Authorized Field Change

AFC G-04906

Subject: Version 11.0 and 17.0 Instrument Cluster Improvement for 3200, 4000, 7000, and 8000 HPV Models Built Between January 5, 2003 and November 26, 2003

Figure 6 New Rear Cover with Interceptor Circuit

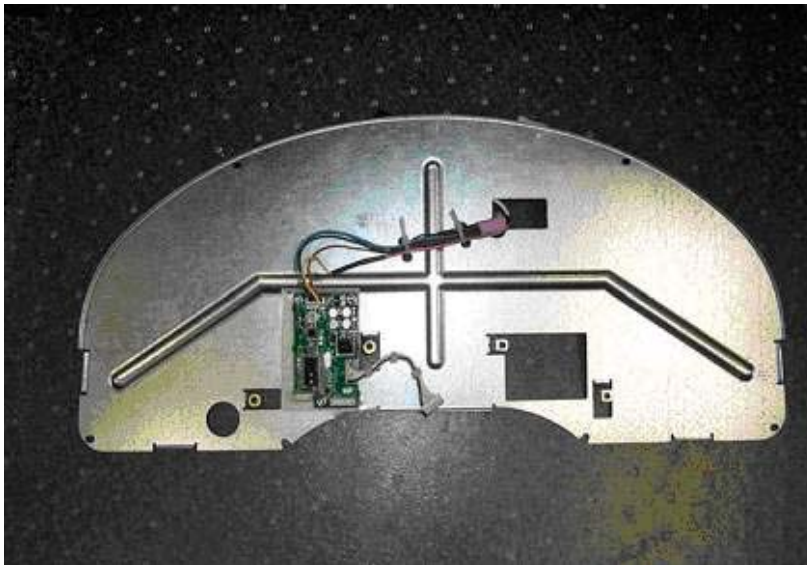
To remedy this , International Truck and Engine Corporation has implemented a program to inspect the current instrument cluster for software version level, and if found to be version 11.0 or 17.0, to replace the instrument cluster rear cover with a new design cover that has an interceptor circuit board attached.

7. Remove new rear cover with interceptor circuit from Kit 8000849R91 (Figure 6).

Figure 10 Connect Interceptor Circuit Display Harness

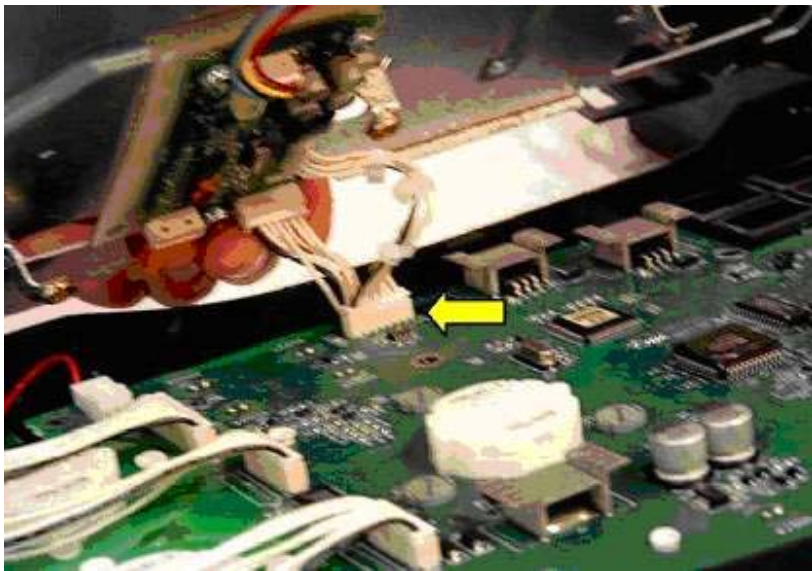
10. Connect Interceptor circuit display harness to the center circuit board (Figure 10).

Figure 11 Interceptor Circuit Connections

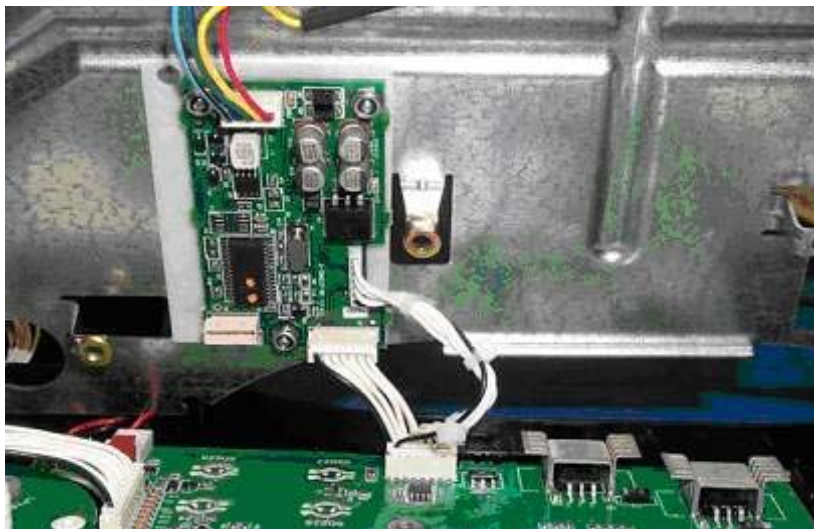
11. Interceptor circuit should be connected as shown in Figure 11.

Figure 12 Connect Main Harness

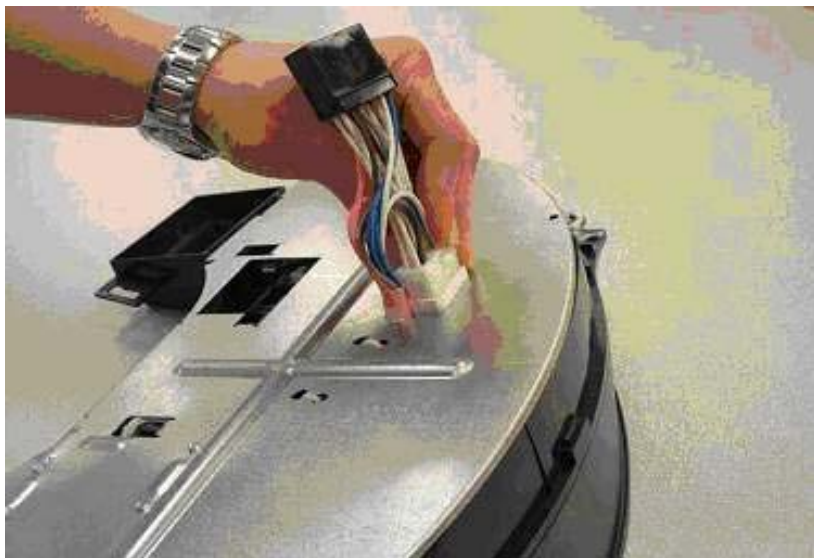
12. Align the rear cover on the cluster and connect the interceptor circuit main harness to the center circuit board (Figure 12).

Make sure the connector from the Interceptor harness is properly seated into the connector of the instrument cluster. An audible clicking sound is heard when connector is seated. Also visually inspect to verify the connection.
